33-KILOVOLT POWER LINE NASSRIYA, IRAQ

SIGIR PA-08-127
JULY 22, 2008

SUBJECT: Report on Construction of the 33-Kilovolt Power Line, Nassriya, Iraq (Report
Number SIGIR PA-08-127)

Figure 2. 33-kV power line drawing (Courtesy of the USACE)

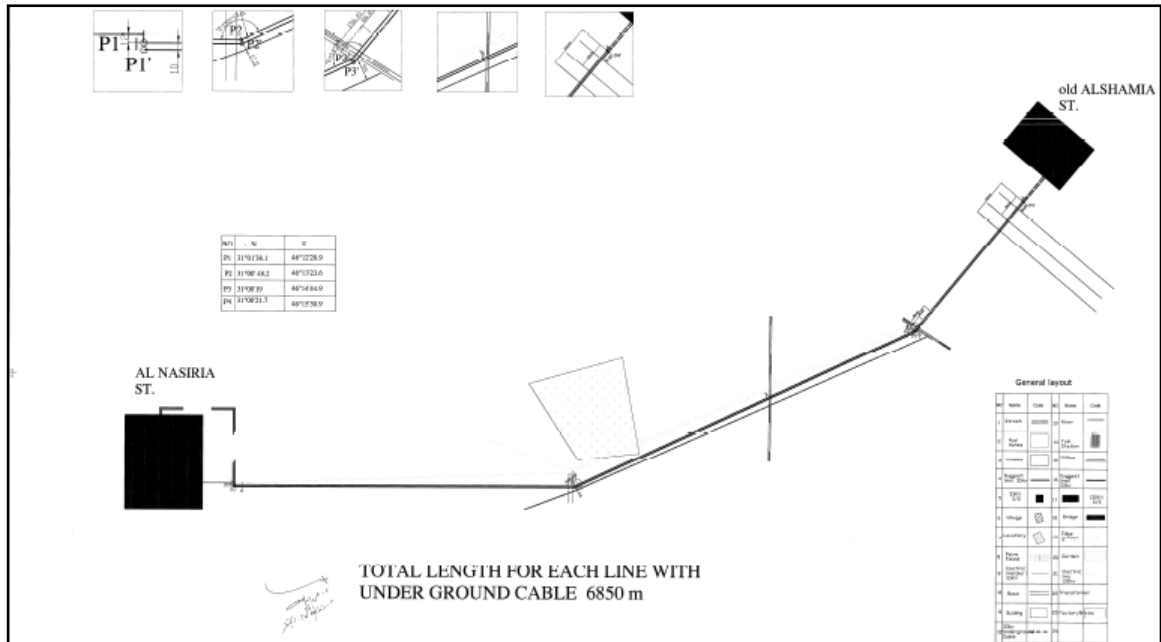
The USACE provided SIGIR with the contractor’s 33-kV power line one page “route” drawing and one profile sheet. The design documents consisted of the route drawing (Figure 2), which provided the total length for each line with underground cable and a profile sheet that determined the height and length between structures. The contractor’s design documents did not provide complete engineering drawings, including construction, civil, mechanical, and electrical, or single line diagrams.

After reviewing the design drawings and specifications supplied, SIGIR determined the design package available was not complete; it lacked sufficient details and did not meet the contract requirements. Specifically, the design documents did not provide any preliminary alignment plans with topographic survey, soil reports, right-of-way plans, construction drawings (which typically includes plan and profile sheets, detail sheets, quantity sheets, and environmental protection plan sheets), structural calculations, foundation calculations, technical specifications, catalog cuts of equipment specified, general design notes with assumptions made, or standard drawings referenced.

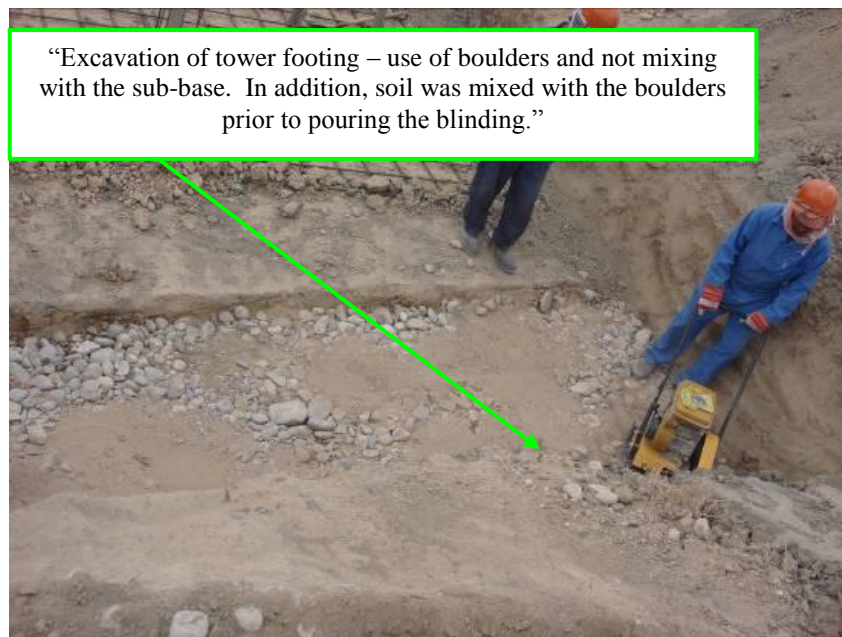
The USACE GRS trained the Iraqi Construction Engineers (ICE), local nationals with engineering backgrounds working for the USACE, and deployed them to the project site to perform QA oversight of the contractor. The ICE were on site during construction events, and monitored field activities and completed daily QA reports, which were forwarded to the USACE GRS project engineer for review. The QA reports documented significant construction activities, such as work performed by building, equipment on site, safety concerns, testing done, and the name and location of the testing facility. In addition, the ICE submits photographs of construction activities taking place throughout the day. Further, the ICE notes any problems/deficiencies identified and the correction actions taken via deficiency logs. Examples of problems noted by the QA representative on site were the “improper excavation and foundation mixing for the tower footing” (Site Photo 11); the potential confusion between the sand that failed the salinity test and the new sand (Site Photo 12); and cube tests (Site Photo 13), which failed the 28-day cure test (Figure 3).
